FERGUSON TOWNSHIP PLANNING COMMISSION
Regular Meeting Agenda
Monday, April 25, 2022, 6:00 PM

2. 2026 Sandy Drive—Centre Volunteers in Medicine Preliminary Land Development Plan

**CENTRE VOLUNTEERS
IN MEDICINE AT
2026 SANDY DRIVE**

PROJECT NO.	21189
DATE	NOVEMBER 11, 2021
SCALE	1" = 20'
SHEET NO.	3

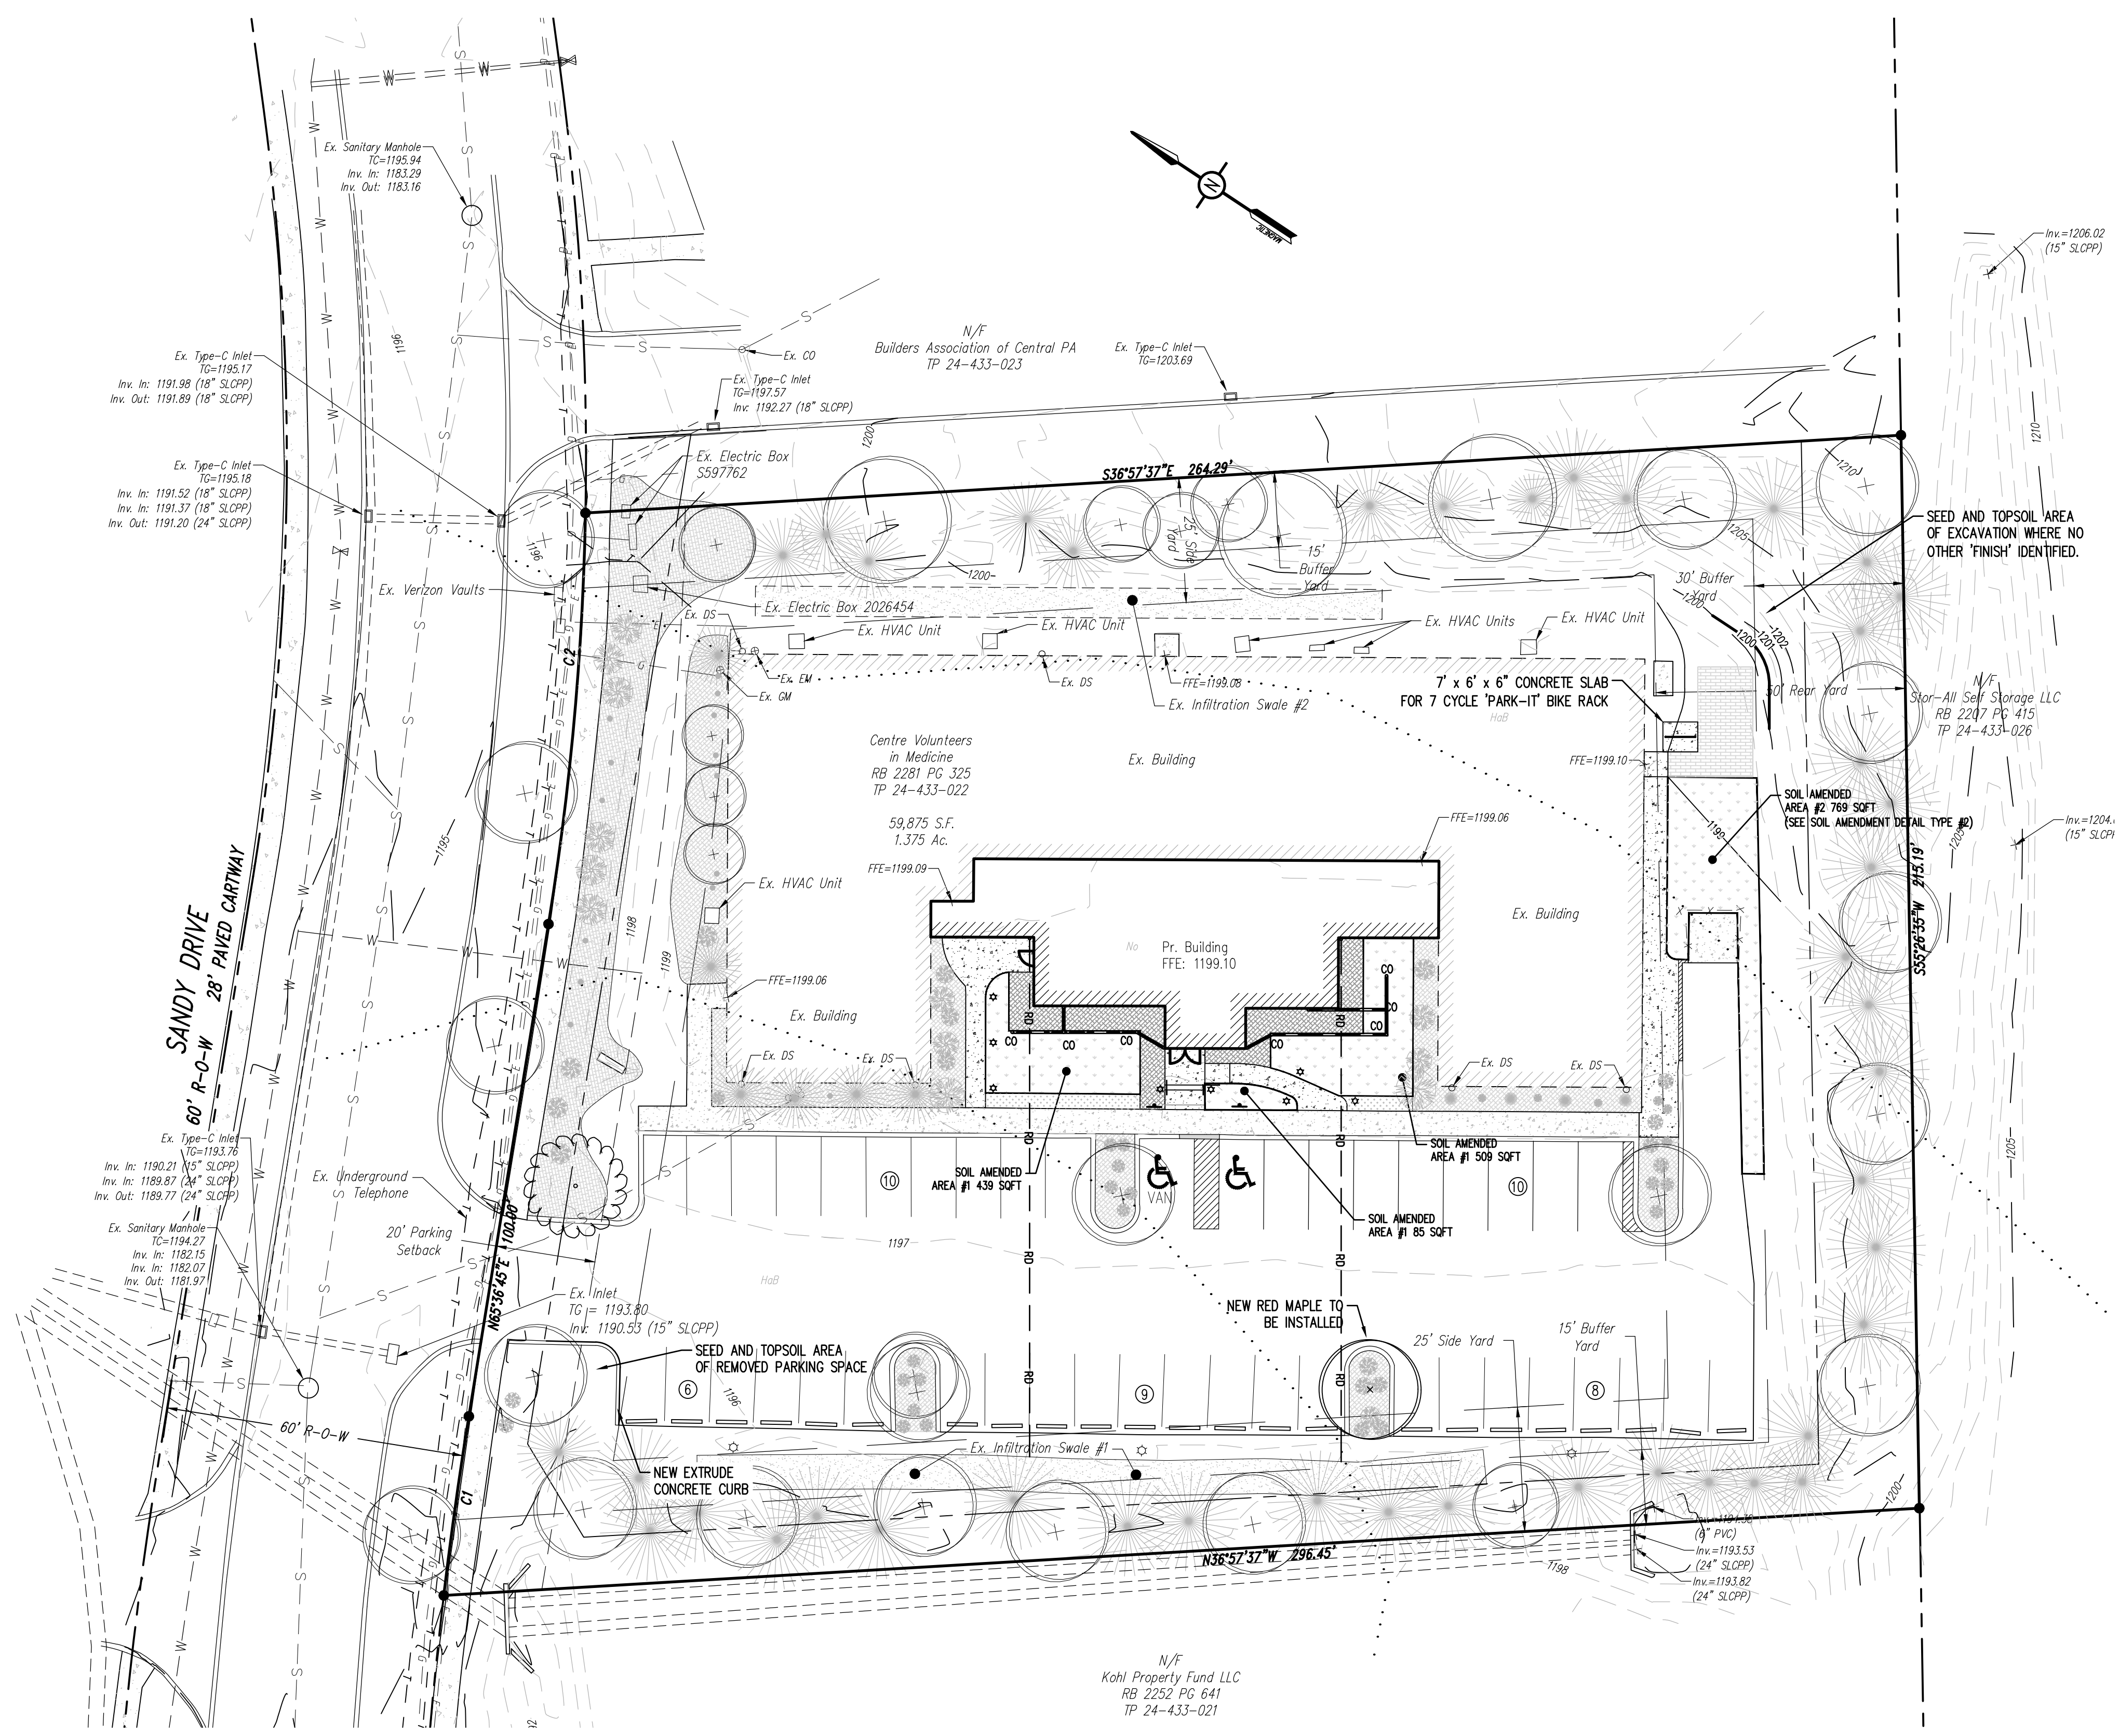
2. All signature blocks on Sheet 3 that are related to stormwater management need to be removed since they are a part of the stormwater management site plan. A separate stormwater management site plan set needs to be prepared in accordance with Chapter 26 and referenced on this plan. All applicable sheets and information related to the stormwater management site plan need to be removed from the land development plan and included in that separate plan set. Sheet 4 should be moved to SWMSP.
Acknowledged.

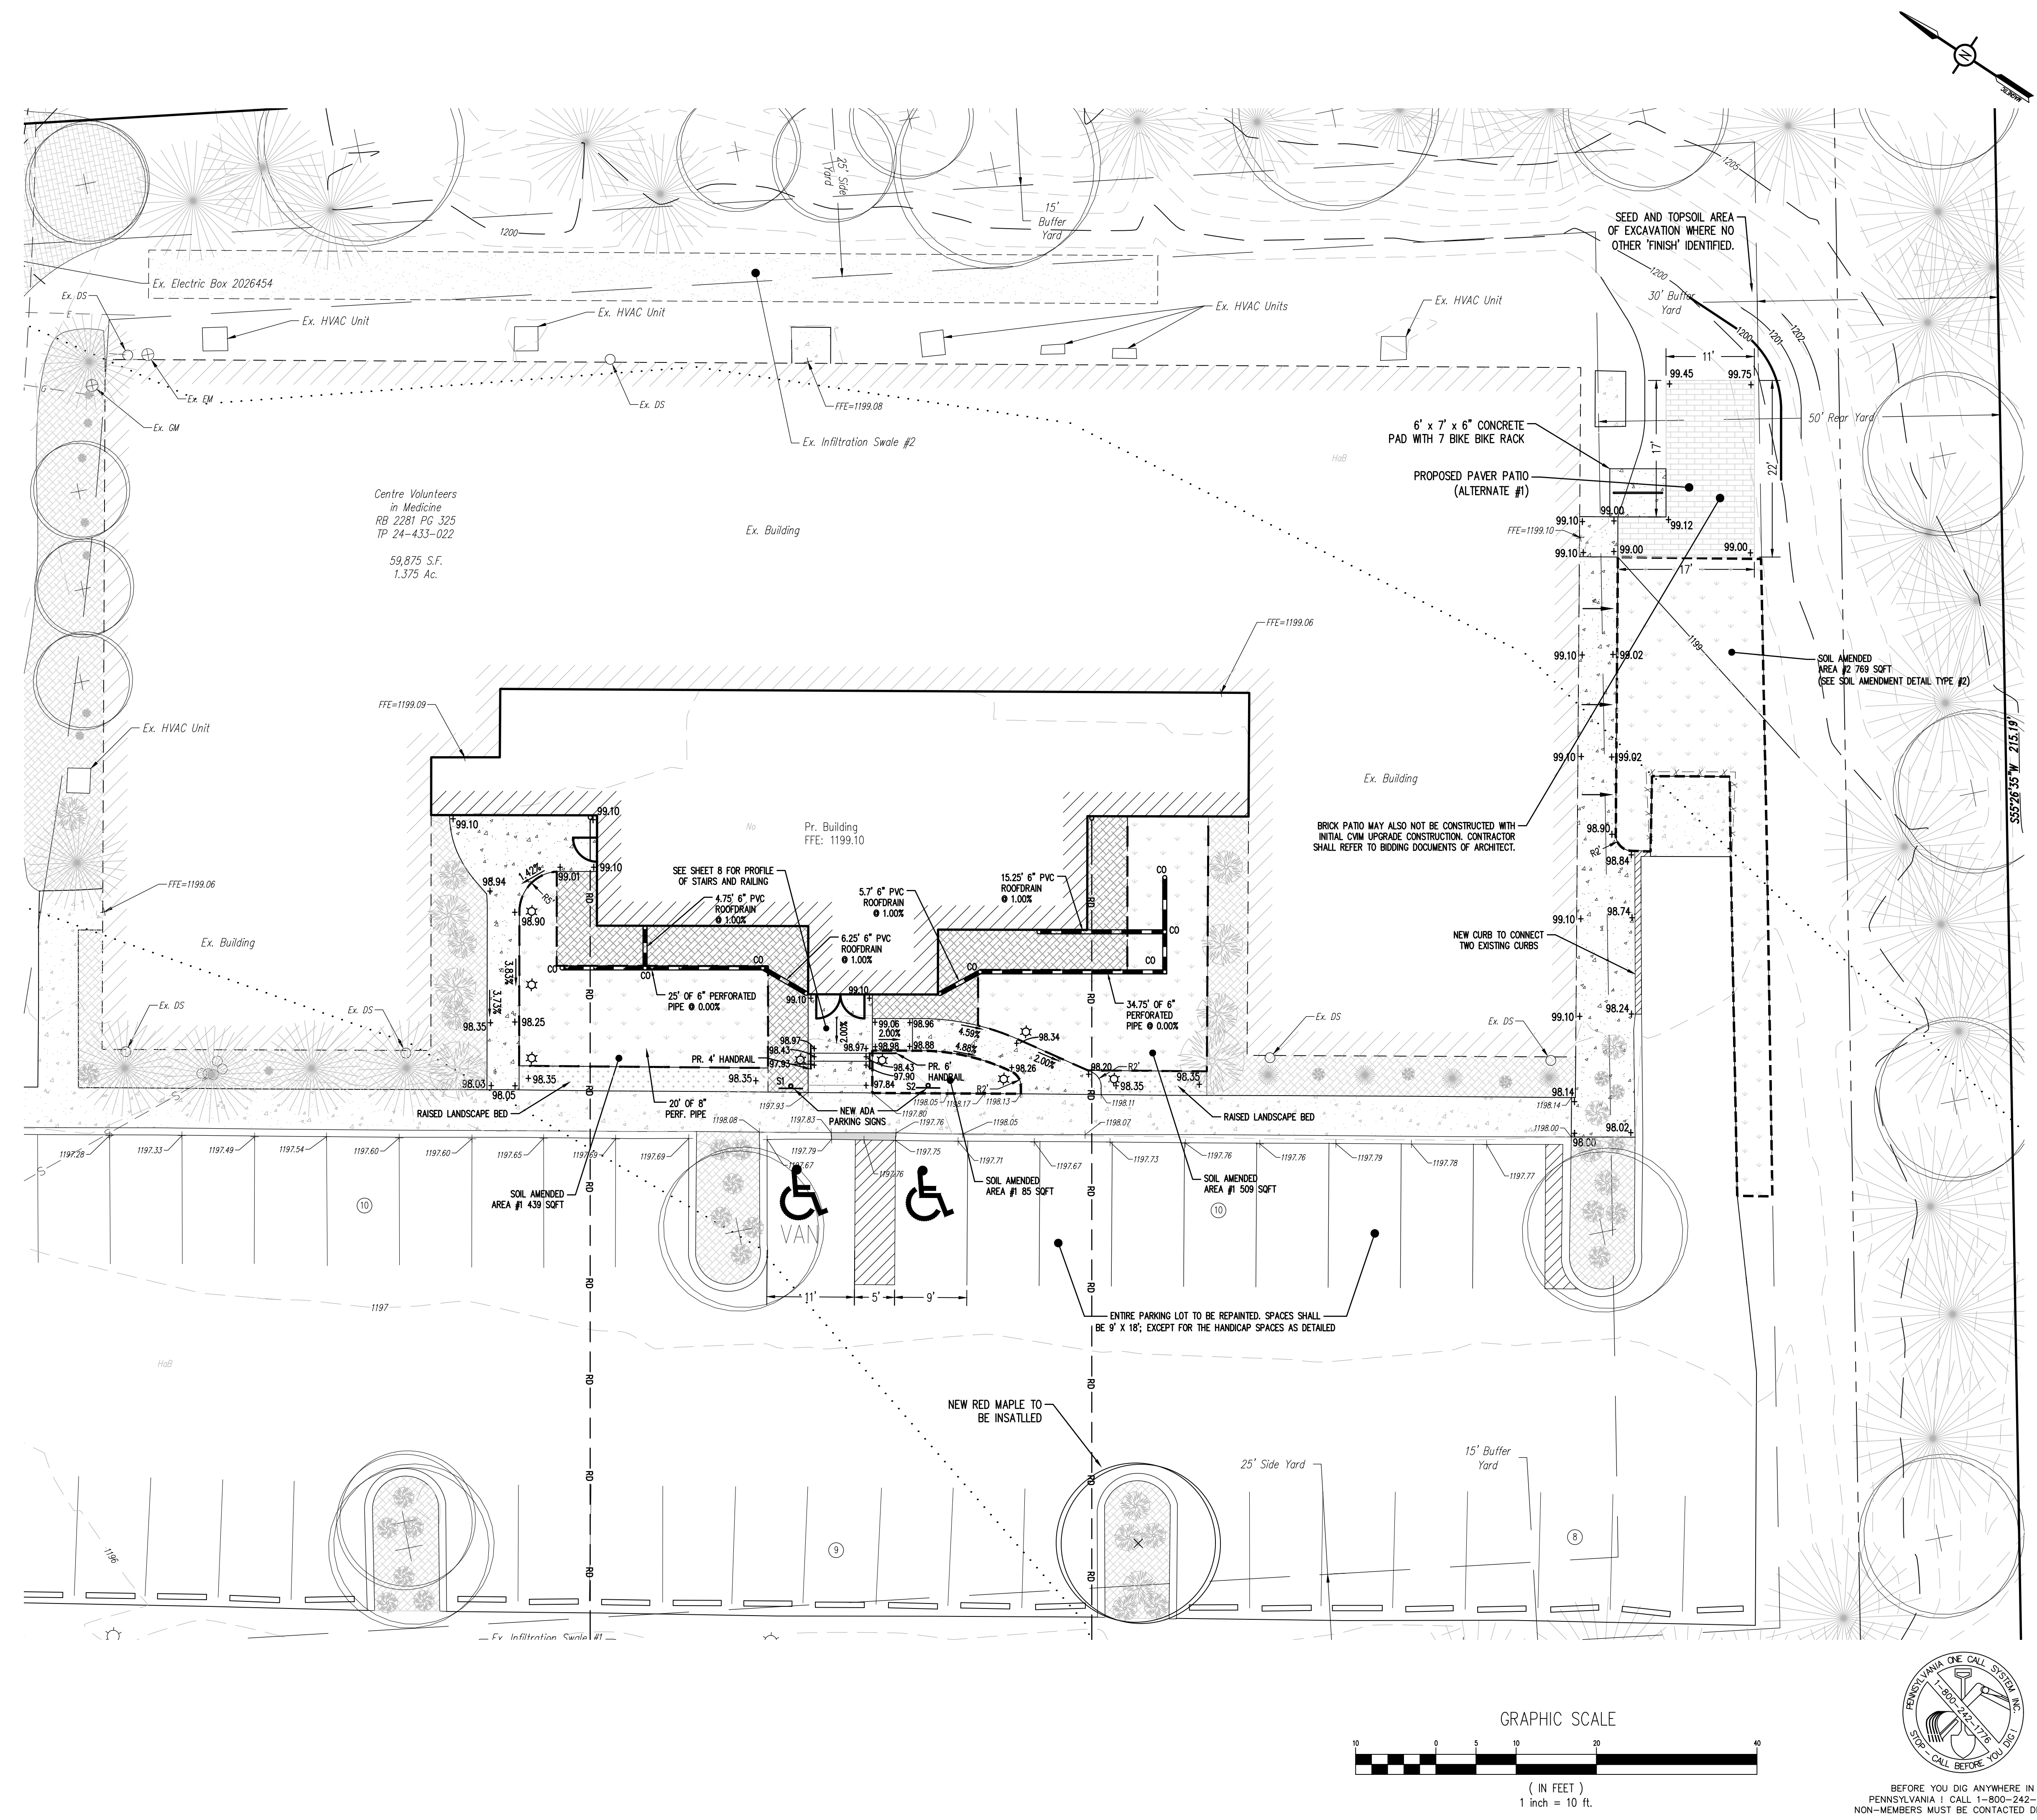
1. Sheet 6 – Existing Tree List Table- misspelling – revise Acer rebrum to Acer rubrum.
This has been revised.
2. Sheet 6 – Existing Trees # 66, 67, 68, 9, 64 are not Black birch trees. Revise to Shademaster honeylocust- Gleditsia triacanthose ‘shademaster’
Revised.
3. Maple tree located on east side of driveway entrance between trees # 1 and # 68 is not indicated with a number or species type. Township Arborist suggest removal and replacement of this tree due to current condition. Large wound on west side of tree that will ultimately result in failure.
The number and species type of this tree is now shown on the plan. We are NOW replacing this Tree #70.
